MEMORANDUM

SUBJECT: *Rockville's Pike: Envision a Great Place* – Work Session #11
Form Code standards - continued

1. South Pike Urban Corridor Building Form Standards, pp. 27- 30, with staff strike-throughs

Table 1.2.3.A: South Pike Urban Corridor Street Frontage**BUILDING PLACEMENT****Key**

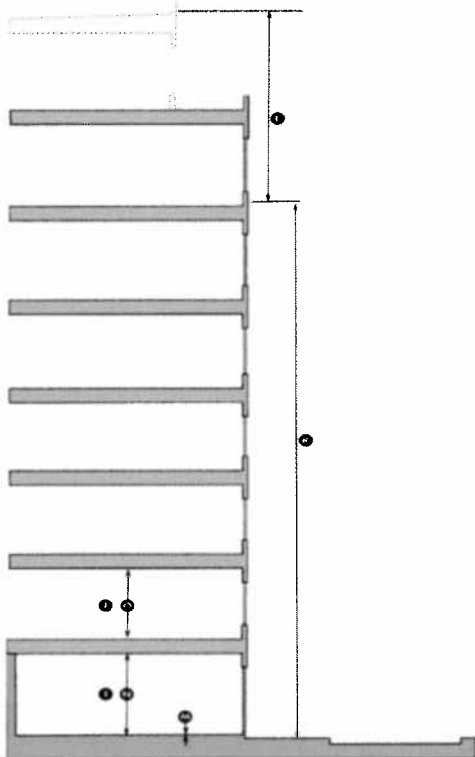
A graphic is provided at the top of page 28 to guide building placement. The build-to line² facing Rockville Pike is set back 40 feet from the property line. In the draft plan cross section, this 40-foot area contains the access road, on-street parking, sidewalk, and landscaped median that separates the through lanes from the local access lanes. The property line in this case begins 60 feet from the center line of Rockville Pike because of the State’s 120 feet of right-of-way. As a result, the build-to line would be a total of 100’ from the center line of Rockville Pike (resulting in an overall recommended 200’ from building face to building face on the Pike). The 1989 plan placed the build-to line for the Pike at 135’ from the center line, resulting in 270’ from building face to building face.

A 25-foot rear setback is required unless there is an alley present, in which case no rear setback is required from the alley. There is no setback from the property line on side streets, meaning that buildings are to be built right up to the sidewalk.

While staff supports a zero setback within each block on the South Pike corridor facing the Pike, staff believes that more flexibility is warranted behind the street front. Staff recommends that this zero side setback only extend 40 feet back from the front build-to line so that there is continuous building at the sidewalk, but areas for open space could be allowed between buildings toward the rear. If a side setback were to be created between lots, the setback would need to meet the City’s building code requirements for separation of buildings.

At least 80% of the building façade fronting the “primary street” must be built at the build-to line under the form code. The consultants have stated that a primary street is intended to be the street that a building’s main entrance faces.³ This compares to the 50% build-to line requirement in the 1989 Pike Plan and the 70% build-to line requirement in the zoning ordinance for mixed use zones where a build-to line is established by the plan. The form code’s build-to line at a side street is a minimum of 50%.

The draft code includes a notation that any lot section along the build-to line not defined by a building must be defined by a 2’6” to 4’6” stucco or masonry wall. Staff recommends that this note be amended to allow for other delineations besides a wall, such as shrubbery or a change in paving material.

The first 30 feet from every corner must be built at the build-to line, with the exception of corner buildings that are meant to be chamfered at specified intersections.

Build-to Line (BTL)Front 40' 58'

Side Street 0'

Setback (Distance from Property Line)Side 0' (*first 40' from BTL only*)Rear ***25' min.**Building Form***

***Any lot section along the BTL not defined by a building must be defined by a 2'6" to 4'6" stucco or masonry wall or other delineations.*

HEIGHT & USE**Use**Ground Floor - *first 40' from BTL* *

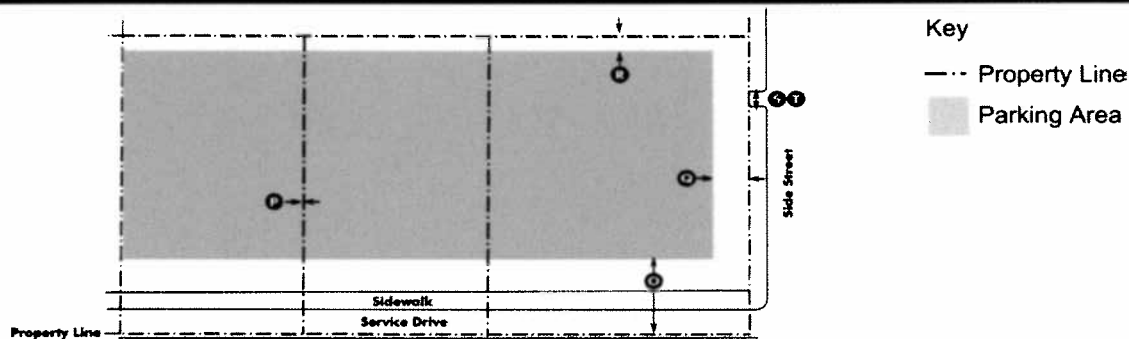
A diagram of building and ceiling heights is provided at the left side of page 28. The form code regulates building height by maximum number of stories rather than by feet. Measuring by stories is more likely to result in greater variation because ceiling heights, interstitial space between floors, and roof forms will be different among buildings.

The building height maximum in the South Pike Urban Corridor is 7 stories. We have received testimony that building heights are too high and other testimony that proposed heights are too low in various portions of the plan area, as noted in staff's September 7 memorandum.

Because this frontage is located less than a mile from the Twinbrook Metro Station and close to other developments that have or will have higher density, staff recommends that maximum building heights be increased to 11 stories for this frontage, with the option for up to two additional stories, contingent on meeting certain requirements. These heights are very similar to the 120-foot and 150-foot heights already codified in the existing MXTD zone. The east side of the South Pike Urban Corridor frontage is currently zoned MXTD, while the west side is zoned MXCD.

Minimum ceiling heights are provided in the building form standards. First floors must have a minimum ceiling height of 15 feet for all frontages except Urban Neighborhood where ground floors would be occupied by lower density residential. The form code requires a 10-foot minimum ceiling height for upper floors. No minimum ceiling height is provided in the current zoning ordinance for upper floors in the mixed use zones (although the City's building code does require a minimum ceiling height of 7 feet or more, depending on use.) The design guidelines for the existing mixed use zones also note that the ground floor "should normally have a ceiling height of at least 15 feet" (25.13.07.2). However, this is not an absolute requirement under the existing zoning ordinance.

There has been testimony in objection to the minimum ceiling height requirement of 10 feet for upper floors, stating that this requirement could result in higher construction and heating and cooling costs, thereby conflicting with the environmental objectives of the draft plan. The justification for this minimum is that it allows buildings to more readily change uses over time.

Staff recommends keeping the 15-foot minimum ceiling height for ground floors but removing the ceiling height minimum for upper floors in the South Pike Urban Corridor frontage.

7 11 stories

***Additional building stories permitted per Section 1.2.3.F (add new section with affordable/family housing, & open space incentives). Step-back permitted per Section 1.1.8.4.B.*

Table 1.2.3.A: South Pike Urban Corridor Street Frontage**PARKING****Location (Distance from Property BTL Line)***

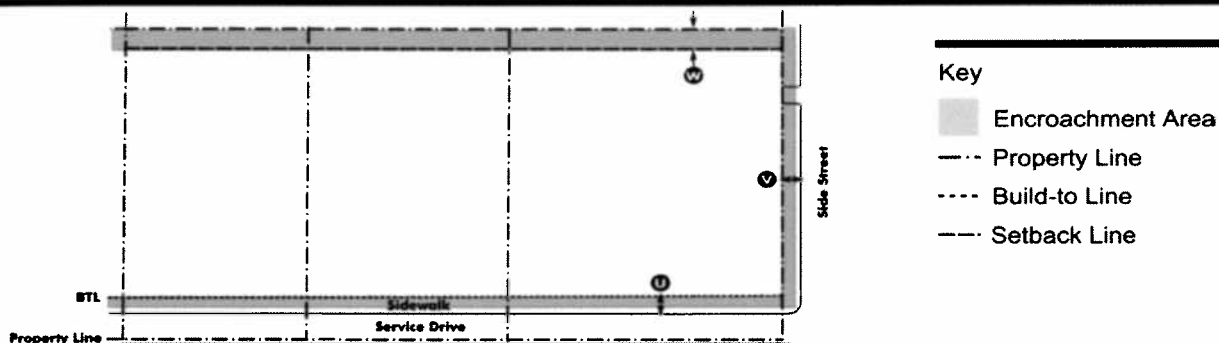
The allowable parking area is illustrated by the diagram at the top of page 29. Parking is set further back than the building at the front and side streets, but the rear setback is 5 feet. As with the building placement, the front setback would need to be adjusted if the boulevard cross section is changed.

Staff recommends measuring the parking front setback from the build-to line instead of the property line because the parking should be defined in relation to the building rather than ownership lines. Staff further recommends that all of the parking setback standards be minimums instead of exact standards, and that underground parking not be subject to setbacks, but be allowed to be located up to the property line.

Front Setback	65' <u>25' minimum</u>	P
Side Setback	0' <u>minimum</u>	Q
Side Street Setback	25' <u>minimum</u>	R
Rear Setback	5' <u>minimum</u>	T

* Parking area setbacks do not apply to underground parking, which may be located up to the property line
